January 5, 2009

Re: IEPA Log No. C-1526-00, COE Log No. 187020-2, City of Springfield, Illinois, Hunter Lake Reservoir

As we will detail below, the proposed project has substantial adverse environmental impacts and fails to satisfy the criteria at 35 Ill. Adm. Code Section 302.105(c)(2) for issuance of a Clean Water Act Section 401 certification. Namely, the project fails to assure that:

Figure 1. Effect of increasing existing South Fork pump capacity

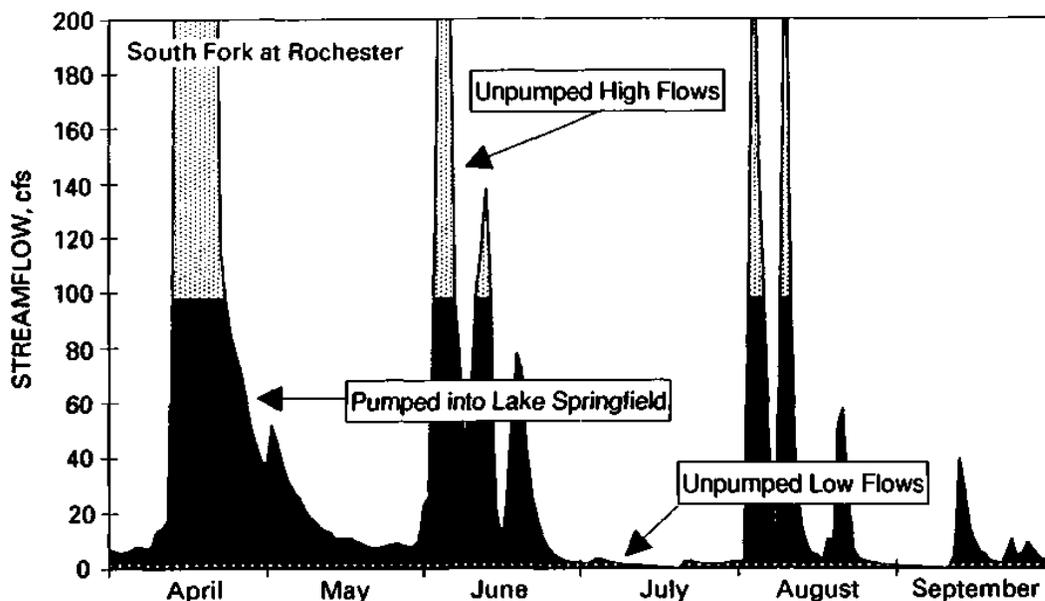
- 5) The South Fork pump station is due for replacement, and its capacity could be increased so it is able to pump more water during the high water periods that occur during drought years as illustrated in the following schematic from the State Water Survey report by Fitzpatrick & Knapp (1991). Since the extra capacity may need to operate only during 50-100 year droughts, the extra pumping power cost may not be decisive, so pipeline enlargement might

not be necessary. To what extent could increasing deliveries from the South Fork reduce the cost of the alternatives listed in Table S2, e.g. by reducing the number of wells or pipelines?

Figure 2. Drought probabilities from Illinois State Water Survey

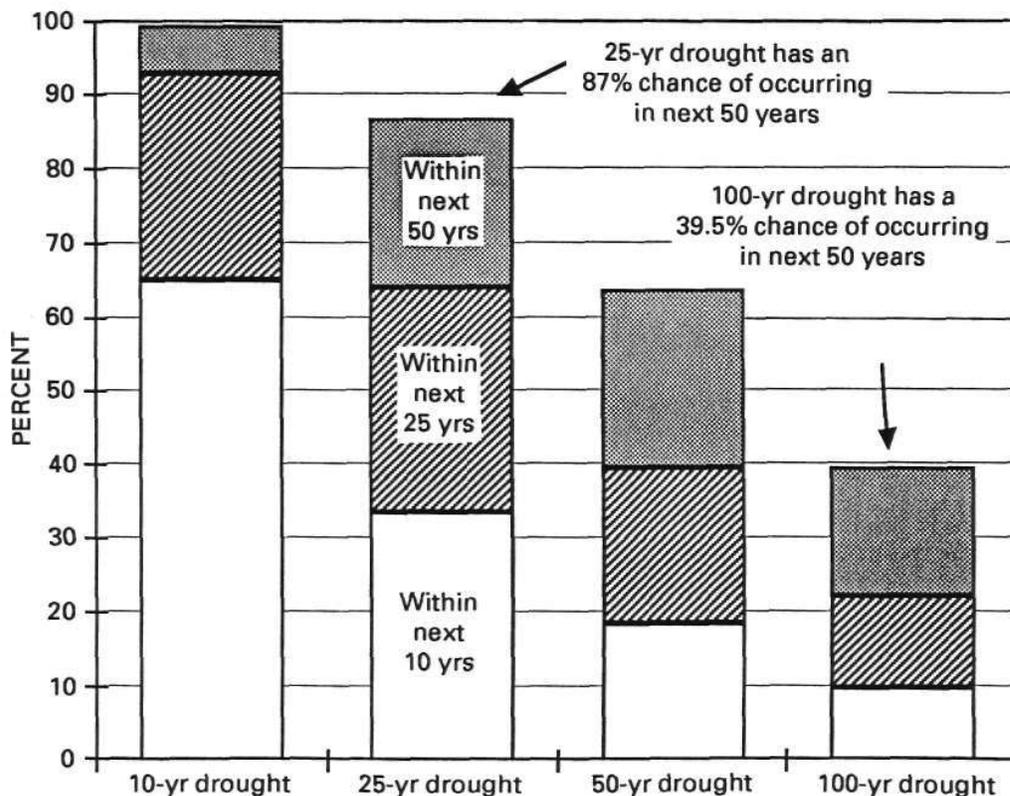
- 2) By comparing the alternatives based on 12 mgd peak demand instead of 9.1 mgd, the applicant has overstated by more than 30% the amount of water actually delivered over the 50-year project life.
- 3) The applicant has also overestimated the frequency of severe droughts (a 100-year drought plus two more droughts more severe than the 50-year drought), thus further overstating the amount of water delivered. In fact the chance of such severe droughts occurring in the 50-year project life is far lower, as shown in the following graph from the Illinois State Water Survey (Fitzpatrick & Knapp, 1991).

- 4) Section 2.2.2 of the FEIS states that “Sources of less than 1 mgd are not considered combinable. Single sources yielding well in excess of the needs of the City are not

considered.” If the applicant’s peak demand does not materialize due to conservation by customers or by the power plant, the cost per gallon of water delivered could become outrageously high, as shown in Fig. 2 above. Water efficiency and conservation was summarily rejected because it was judged too small; why shouldn’t IEPA and COE reject Hunter Reservoir for being too large?

Figure 3. Summer and winter water use (27 years)

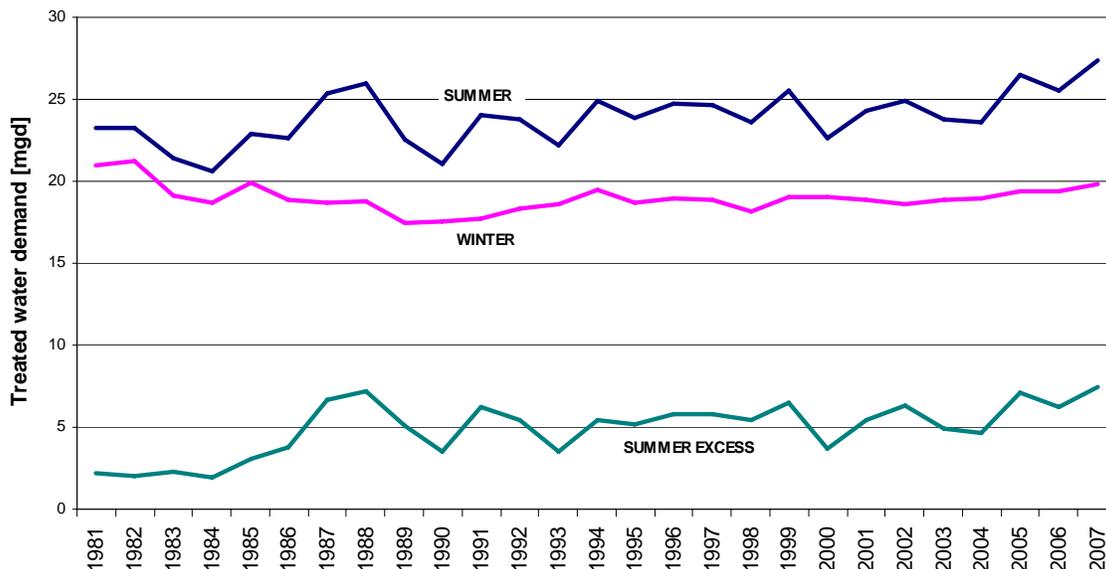
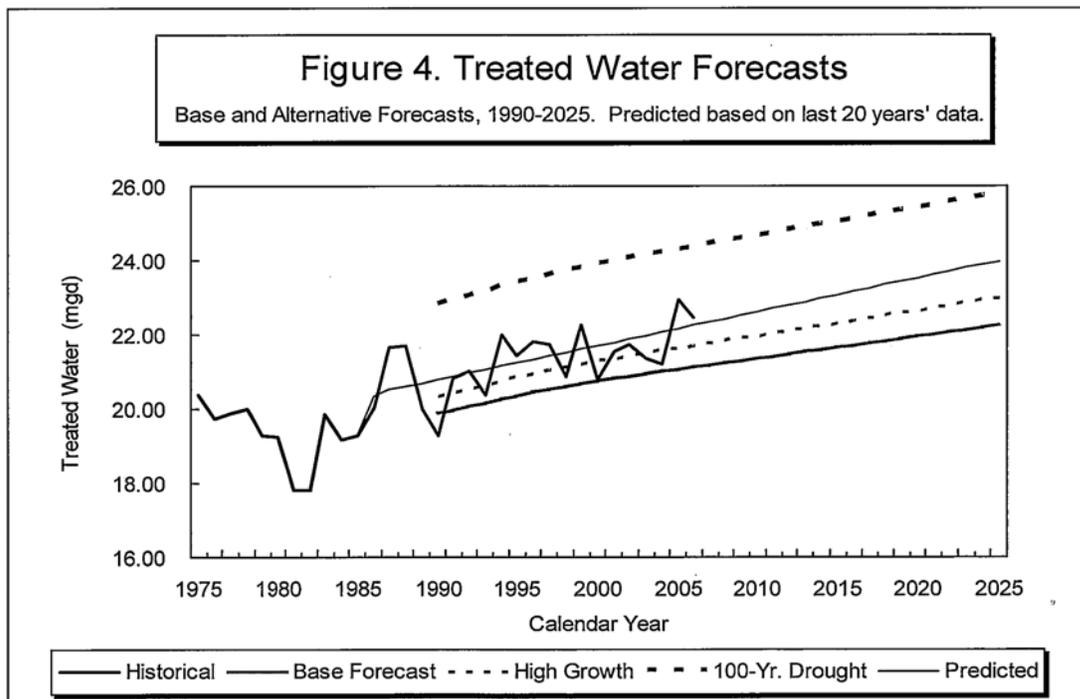
Water demand has been almost flat in Springfield for 27 years; the only part of demand that is increasing is summer use which is mainly lawn watering, golf course irrigation, etc. The following graph compares summer and winter (Nov-Apr) usage, from data provided by the Illinois State Water Survey (2008). By failing to consider substantial restructuring of water rate schedules to encourage more efficient use, demand growth has been overestimated.

- 1) Seasonal pricing to promote more efficient water use in summer was considered and rejected for being “too small” in the FEIS., which estimated <0.1 mgd savings. That result is not credible, because the PMCL (1991) economic model assumed that price has no effect on non-residential water demand, and it grossly underestimated the effect on residential use by reliance on average rather than marginal prices and on price elasticities picked from the low end of the cited range. Electric utilities have used seasonal pricing for decades to reduce peak demands; see the vast technical literature on load shaping, load management etc. By what amount would peak demands be reduced through an aggressive program of seasonal pricing, for example by raising the summer rate by a factor of 3 or 5 and returning the revenues in a way that does not create incentives to increase water use (e.g. abolishing the fixed meter charges, charging little or nothing for a subsistence amount of 3-4 units/month for residences, or by reducing city sales or property taxes)? Unlike investor-owned utilities, municipal utilities are not constrained to cost-based ratemaking; are there records of the applicant analyzing and presenting such alternatives to the City Council?

- 2) The 20-year trend extrapolation (CWLP 2007b Figure 4 shown below) captured only partially the introduction of federal plumbing fixture efficiency standards which began to take effect in 1994 and will continue for decades. Likewise the extrapolation fails to account for the federal appliance efficiency standards that will reduce laundry and dishwasher water use ~40% beginning in 2010. Please adjust the demand forecasts to account for these federal laws and regulations.
